INSTRUCTIONAL BULLETIN NO. 17-09

Regarding Revised Standard Drawings

Effective February 9th, 2018 letting (November 29th, 2017 Turn-in), the following Standard Drawings have been revised. Also, Section 5, Index of Standard Drawings, of the Roadway Design Guidelines has been revised to incorporate these changes.

EC-STR-11

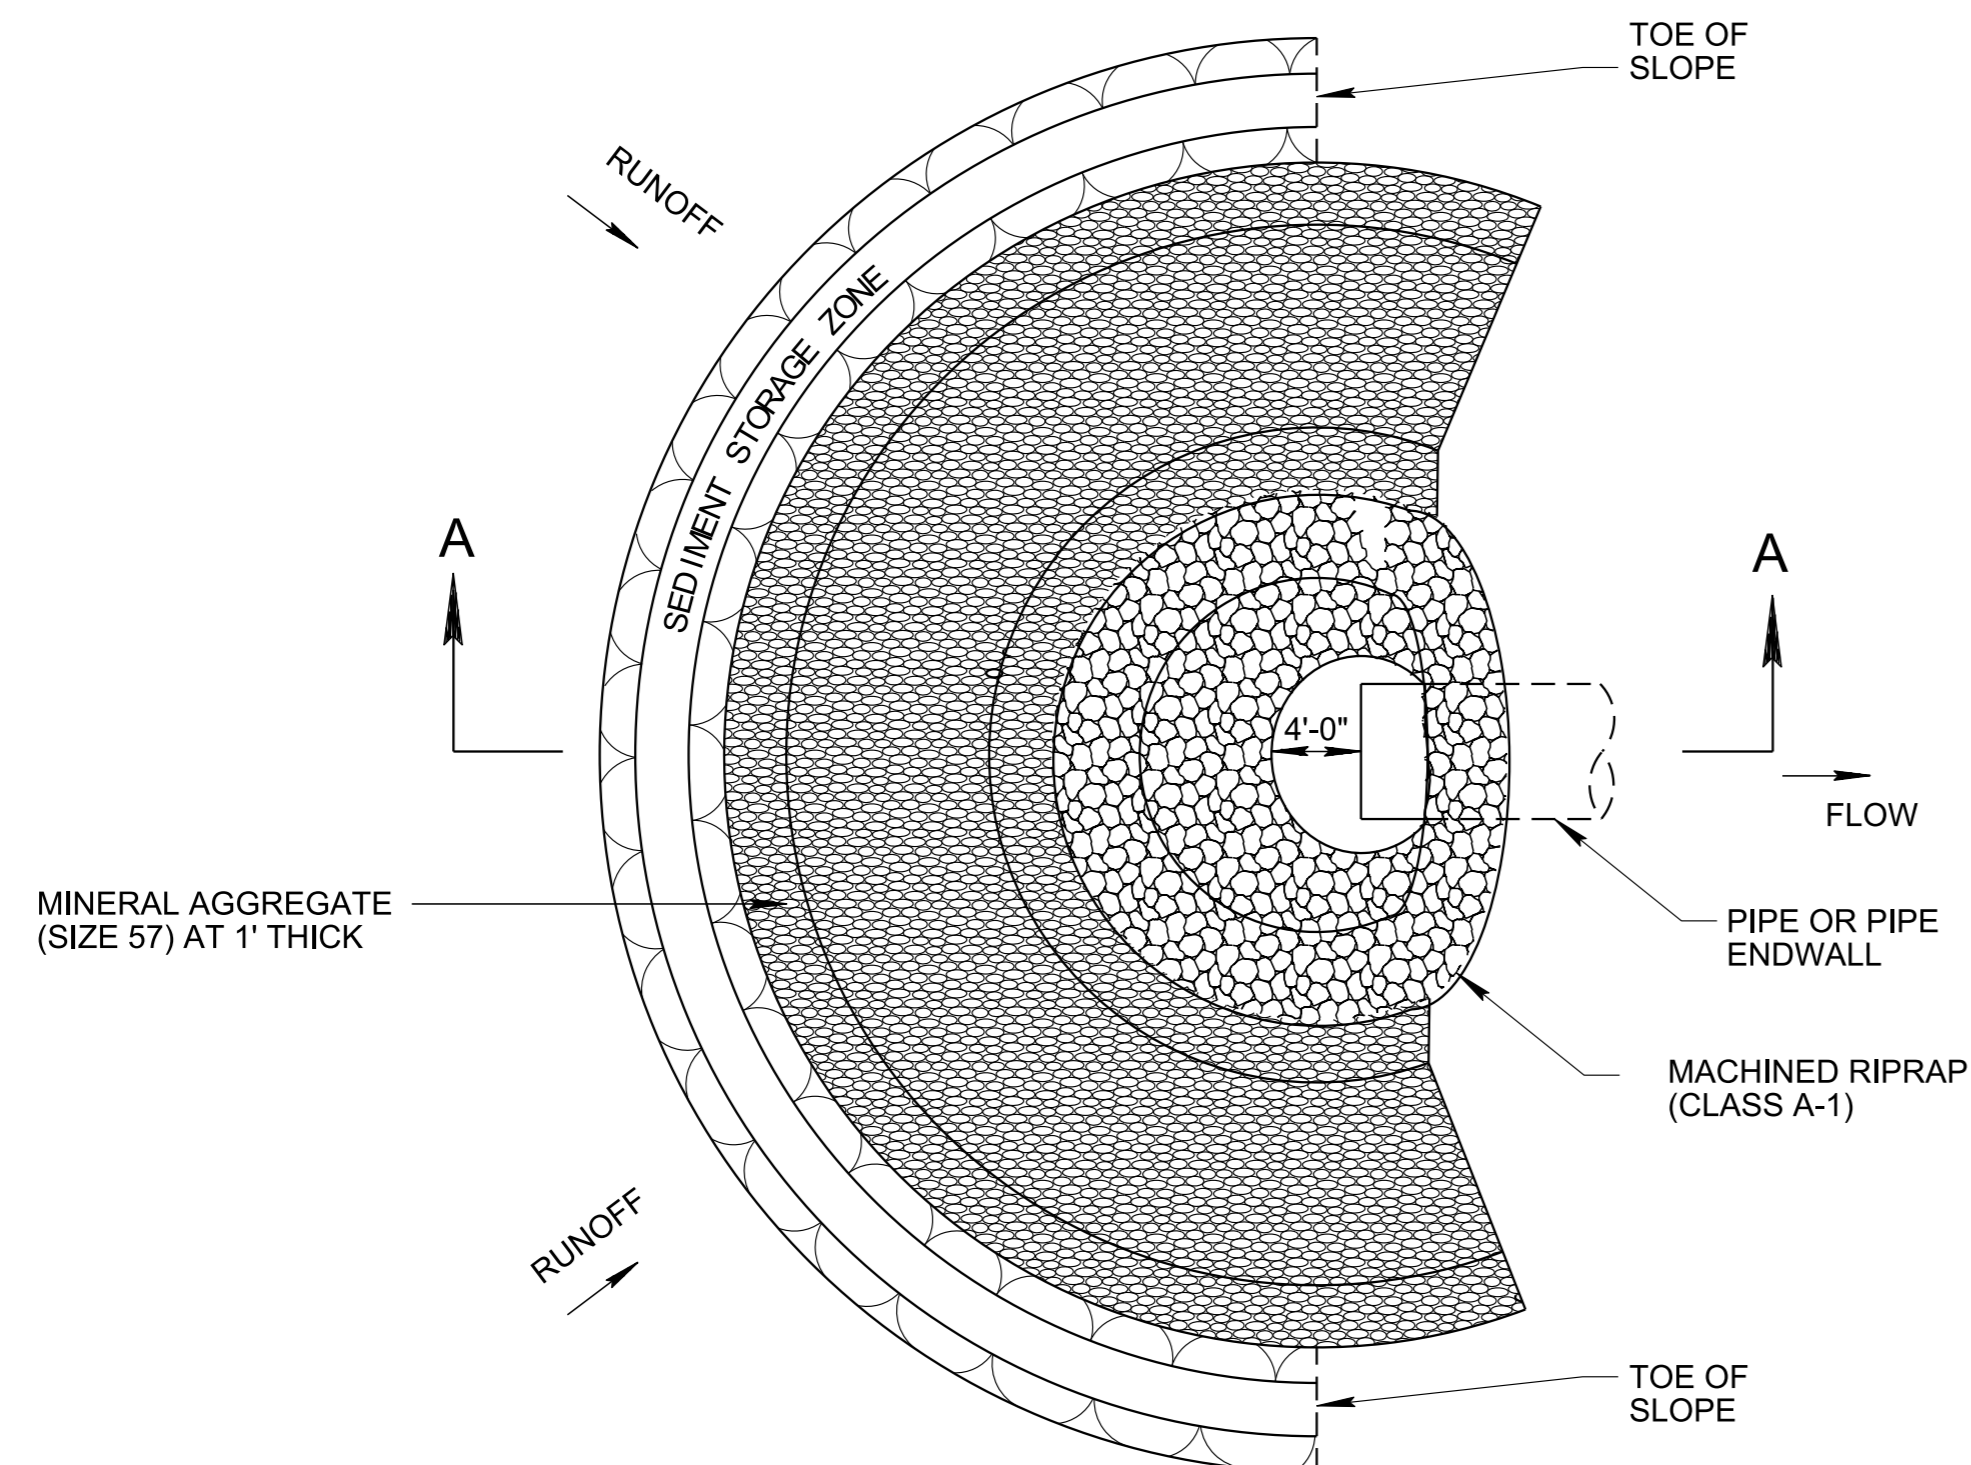
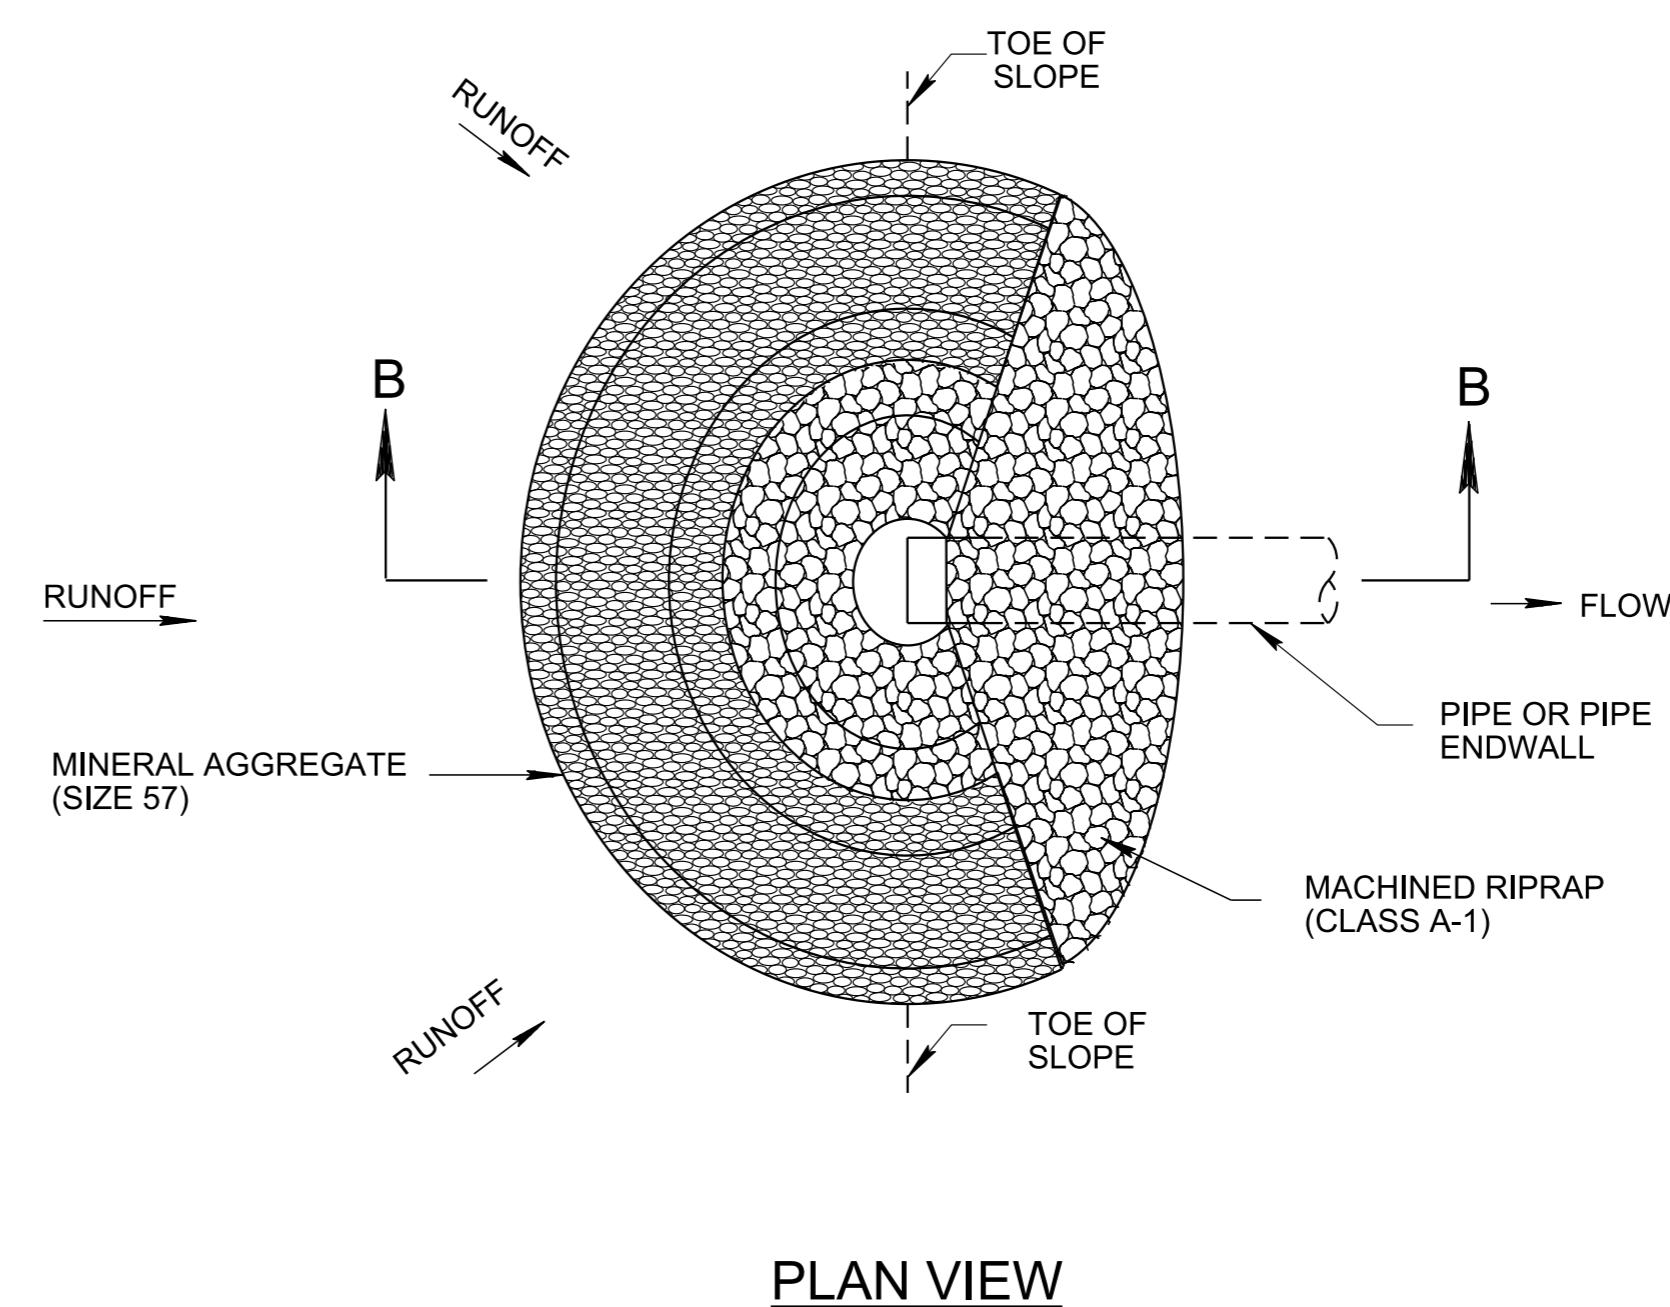
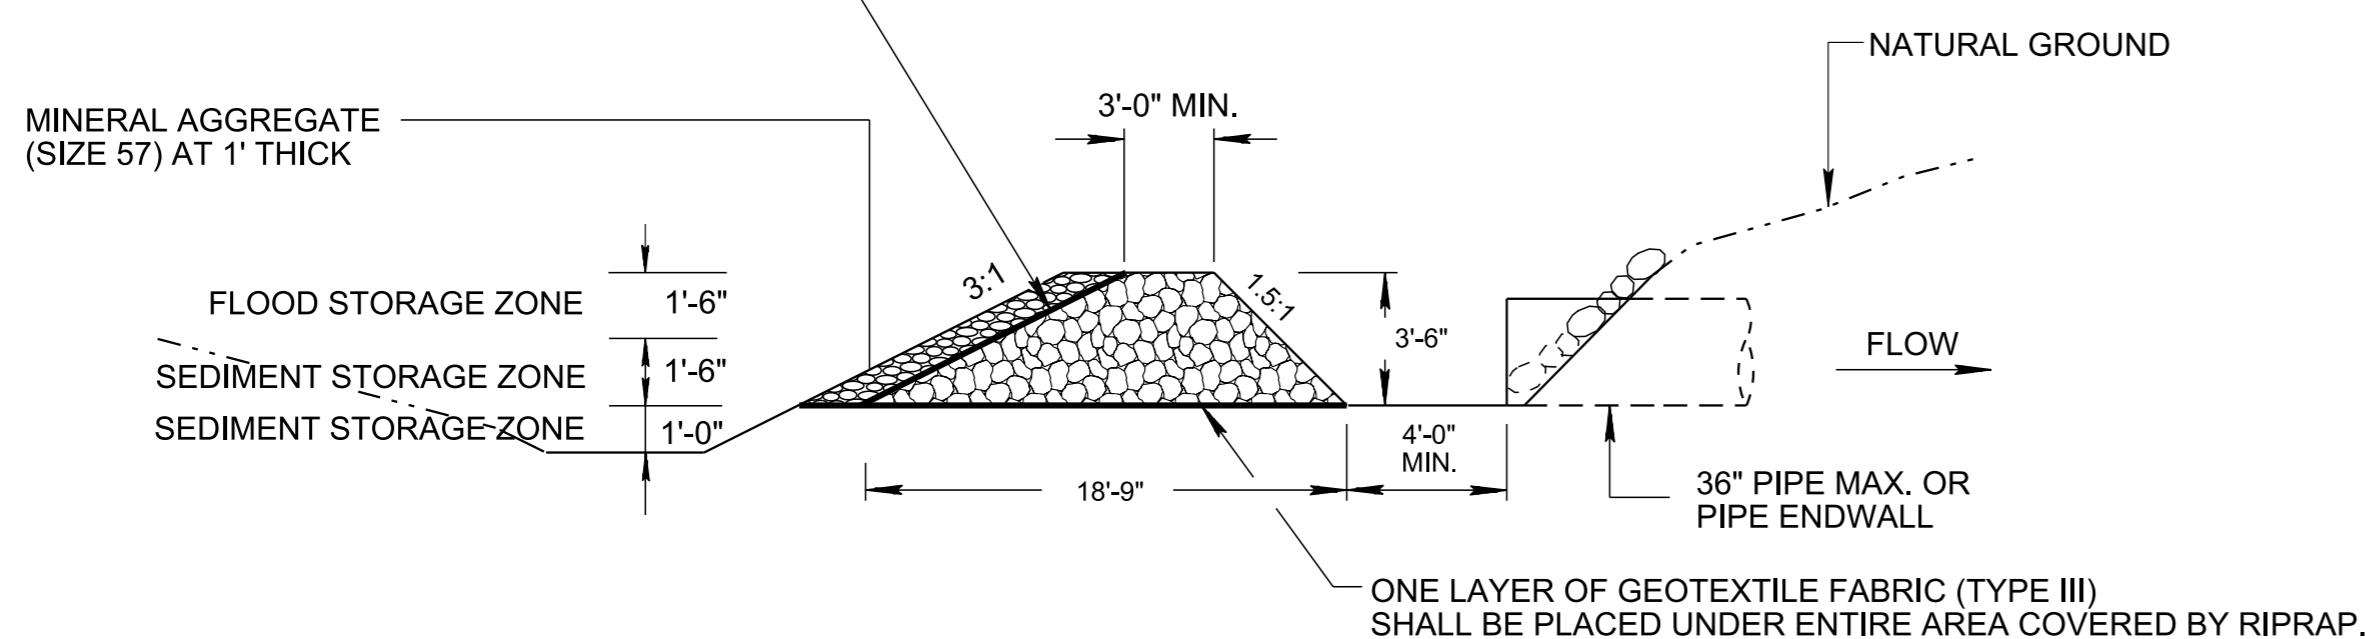
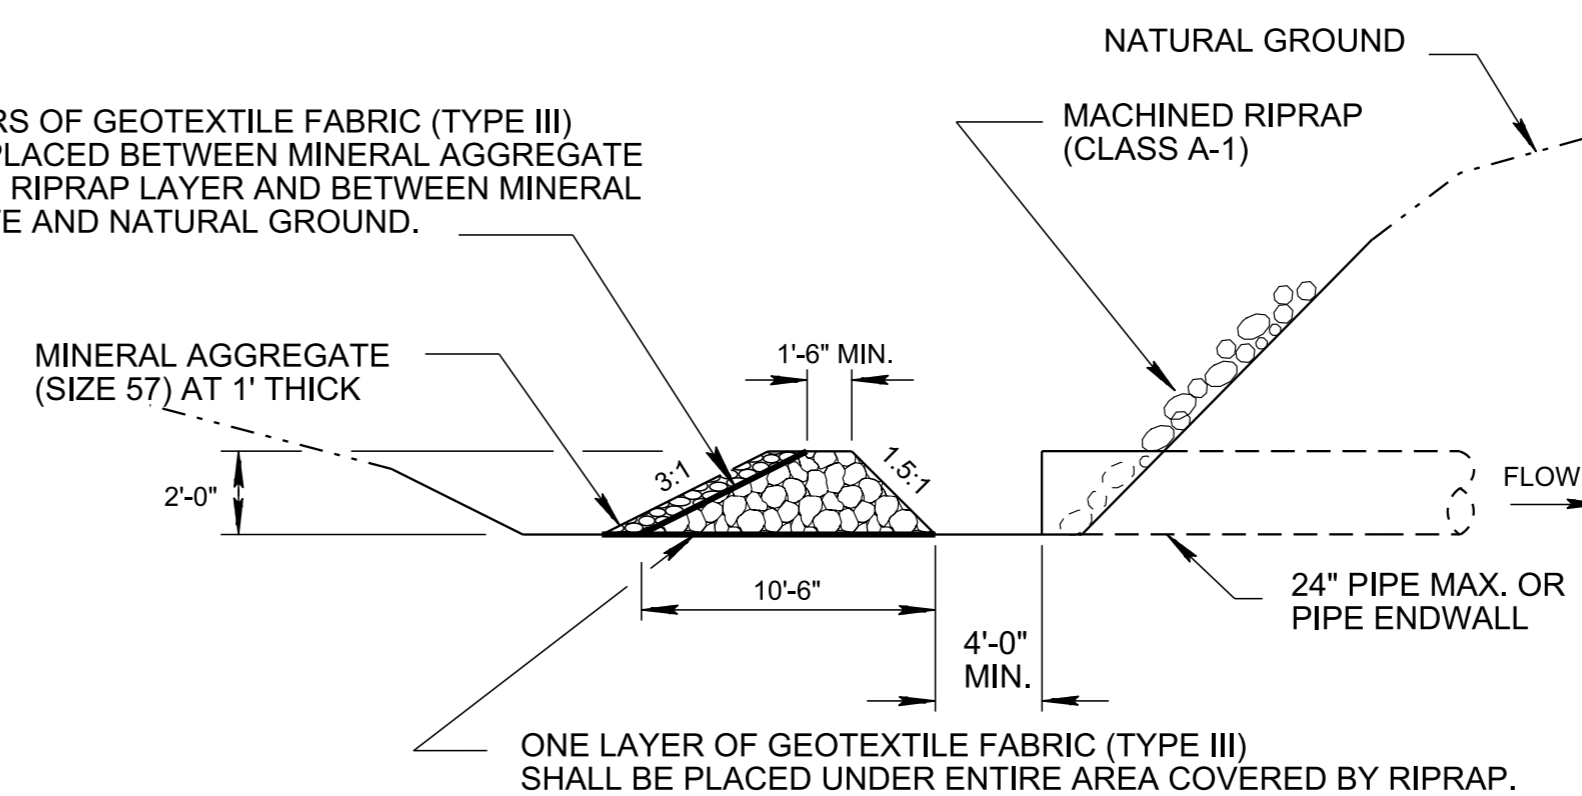
REV. 3-16-17: CORRECTED PAY ITEM NO. 209-05.
